City of Hamilton

PUBLIC WORKS COMMITTEE REVISED

Meeting #: 21-016
Date: November 1, 2021
Time: 1:30 p.m.
Location: Due to the COVID-19 and the Closure of City Hall (CC)

8.1.	Hamilton Water Leak Detection Program (PW21063) (City Wide)	82
8.2.	Update to Hamilton's Solid Waste Collection Design Guidelines for Developments (PW21061) (City Wide)	107

2 1430 MAIN STREET - PROPOSED HAMMERHEAD IMPACTS
A0.01 1:150

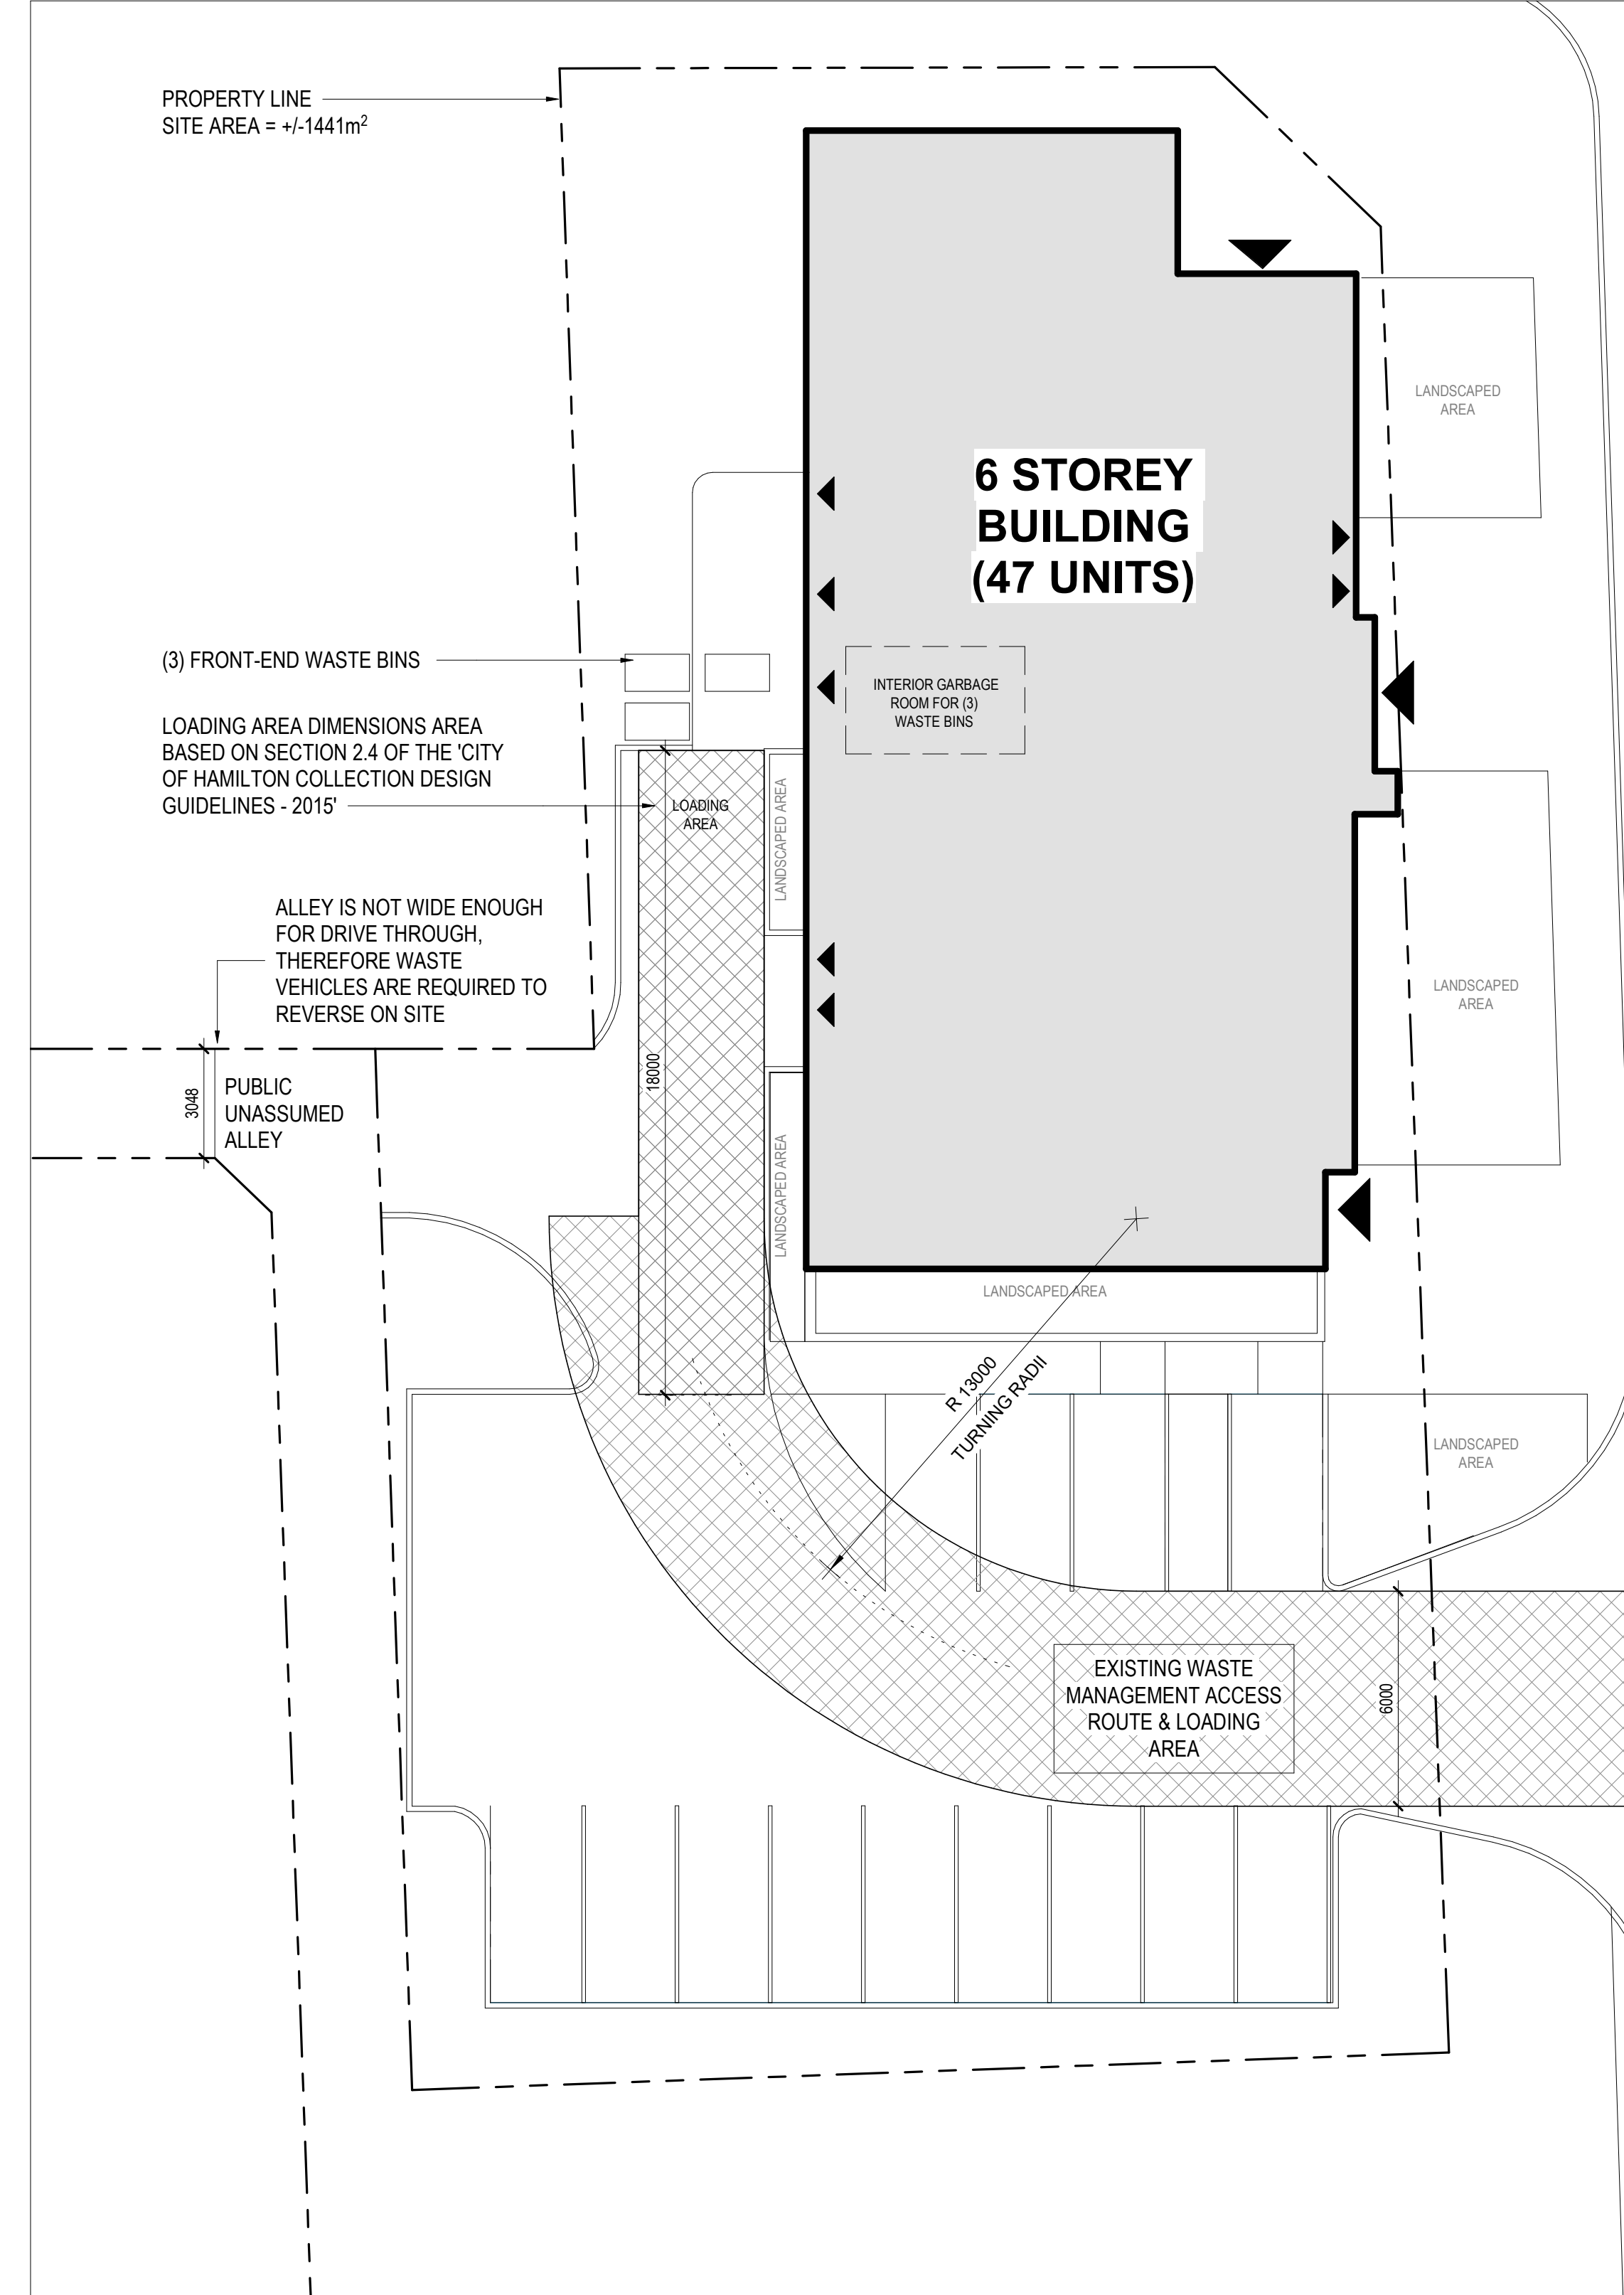
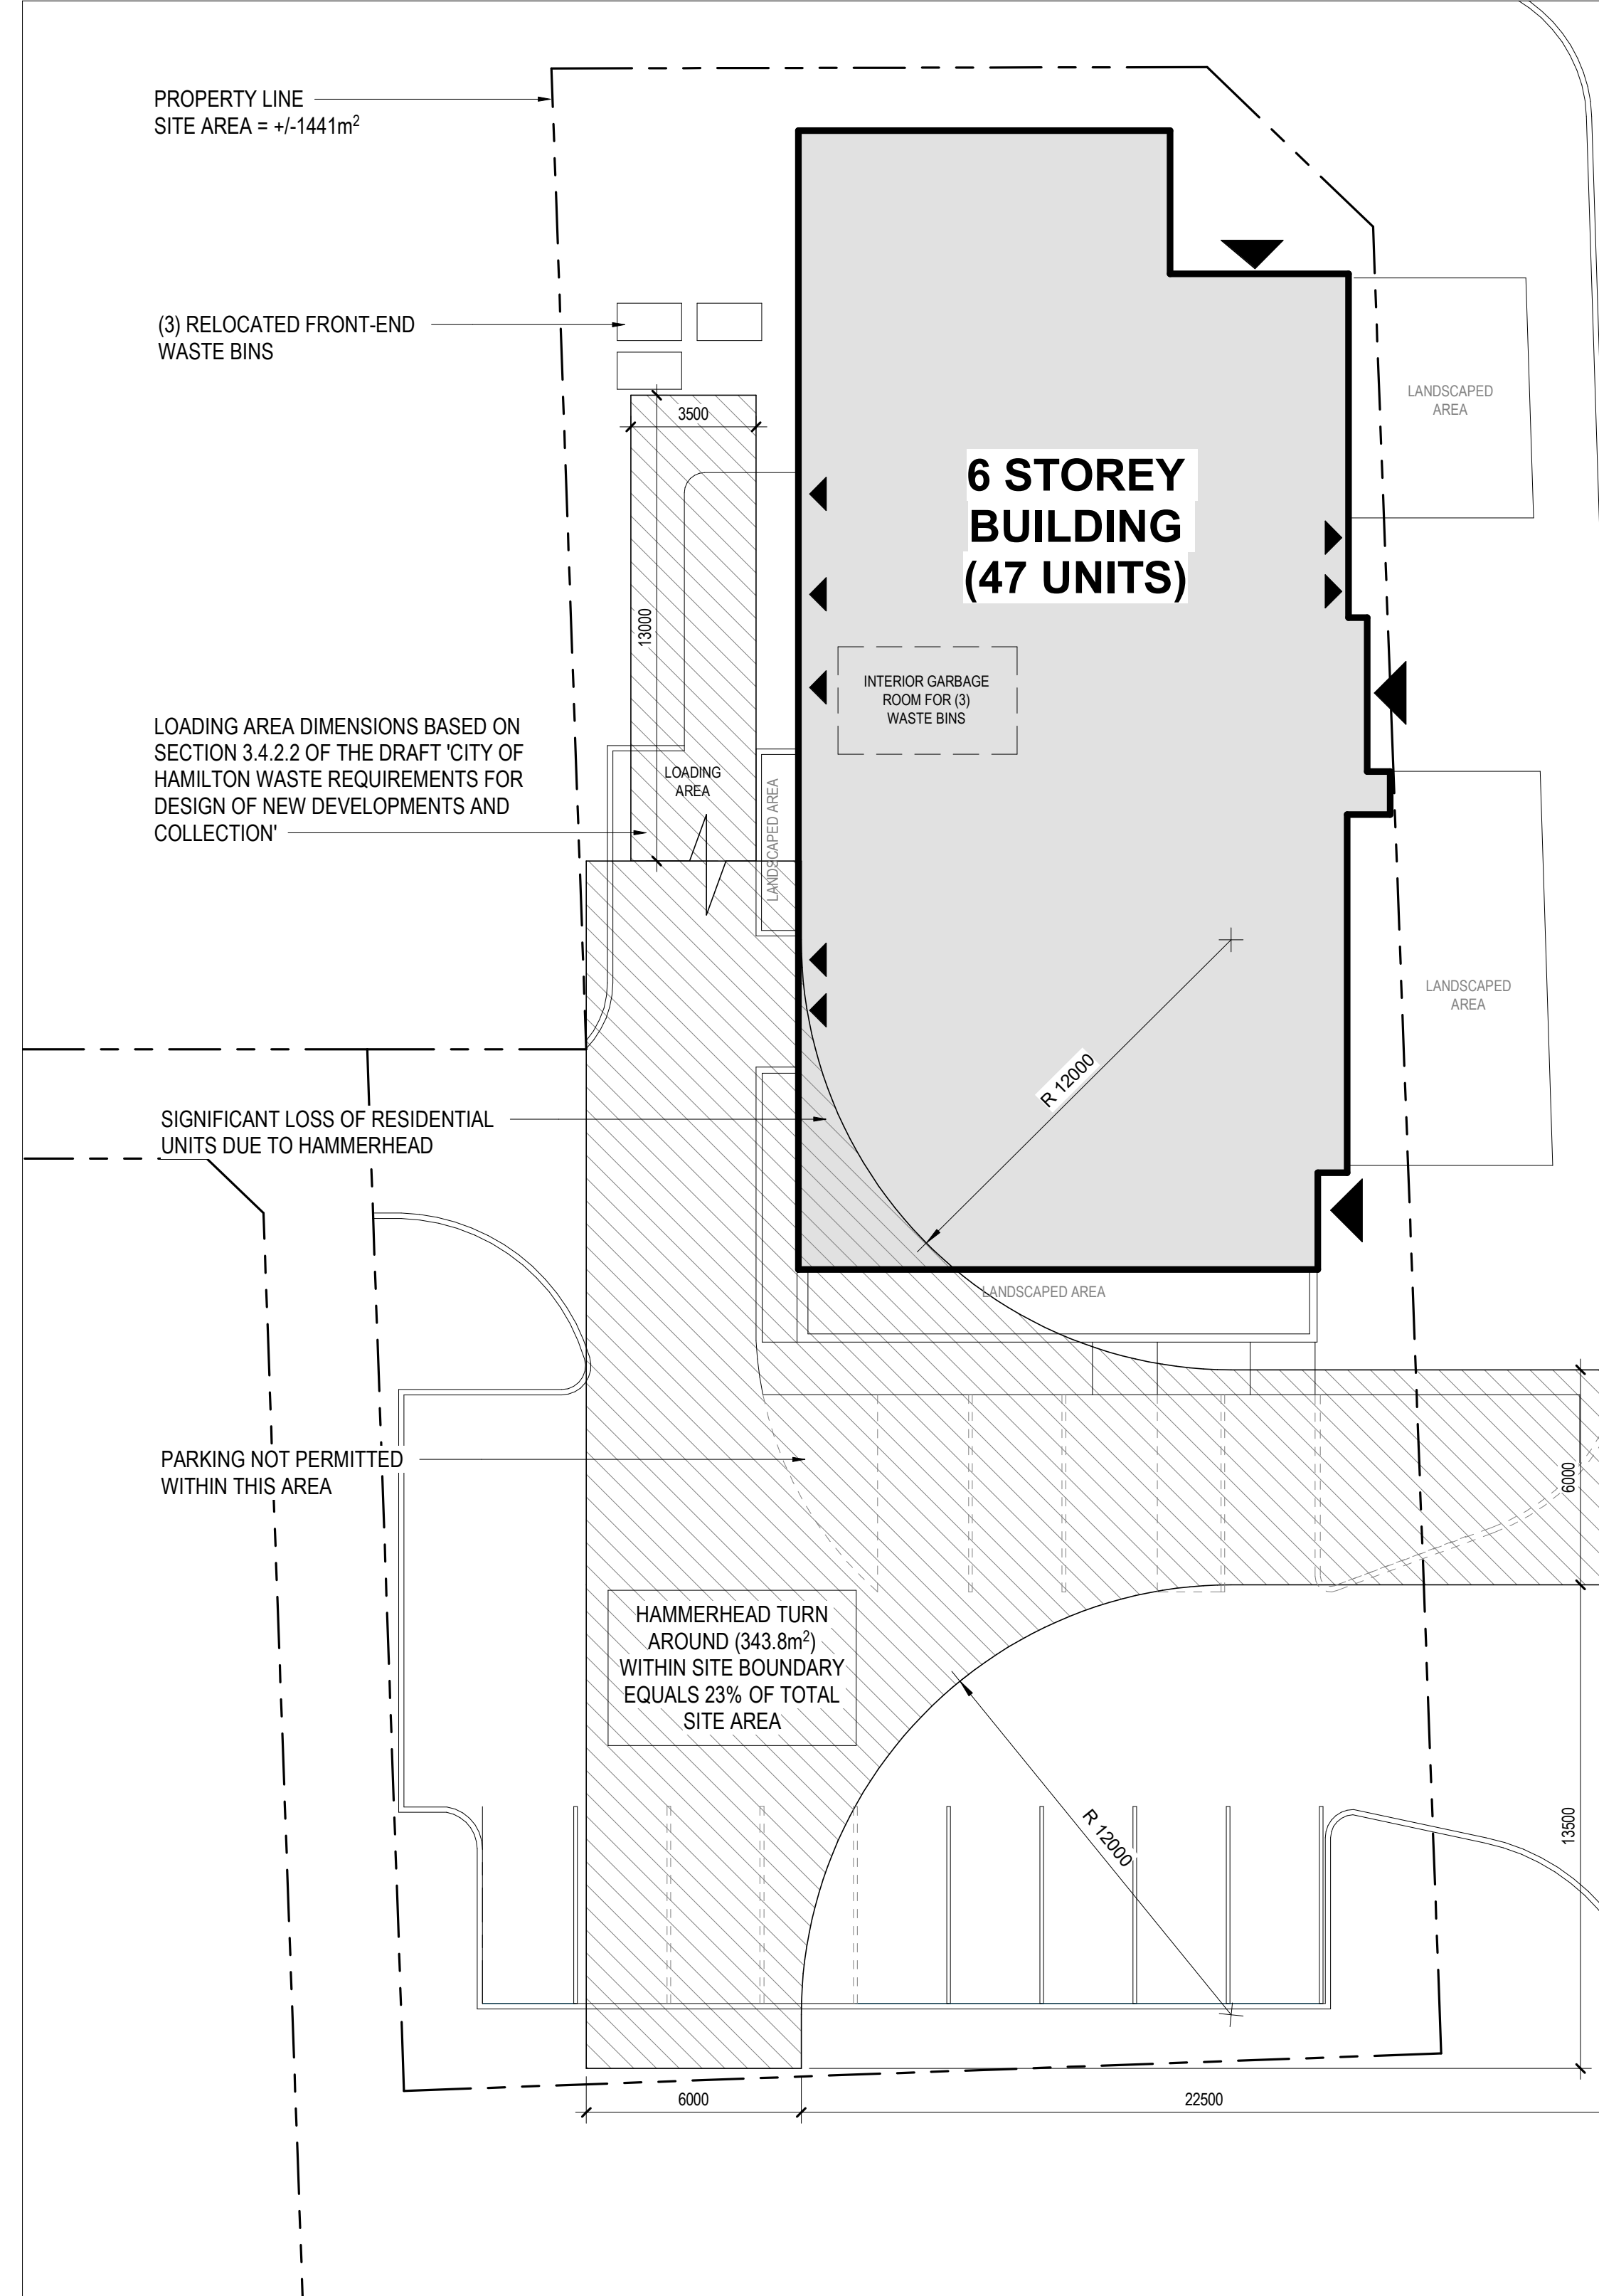
SITE RESULTS DUE TO PROPOSED DRAFT HAMMERHEAD

- SIGNIFICANT LOSS OF PARKING DUE TO HAMMERHEAD SPACE REQUIREMENTS (7 SPACES LOST)
- REDUCTION OF BUILDING AREA AND RESIDENTIAL UNITS DUE TO HAMMERHEAD SPACE REQUIREMENTS (MIN. 6 UNITS LOST)
- LOADING AREA IMPEDES EXITING AND EGRESS AT THE REAR OF THE BUILDING
- GOALS FOR INTENSIFICATION WOULD BE REDUCED DUE TO PROPOSED HAMMERHEAD REQUIREMENTS

TOTAL LOSSES:

47 UNITS IS REDUCED BY 6 TO 41 UNITS BASED ON BUILDING AREA CLEAR OF HAMMERHEAD

REDUCTION OF PARKING MEANS FURTHER REDUCTION OF UNITS (BASED ON SECTION 5.6 OF BY-LAW 05-200 ASSUMING UNITS AS >50m², AT 0.5 PER UNIT A FURTHER REDUCTION OF 14 UNITS OCCURS)

47 UNITS - 6 UNITS - 14 UNITS = 27 UNITS TOTAL
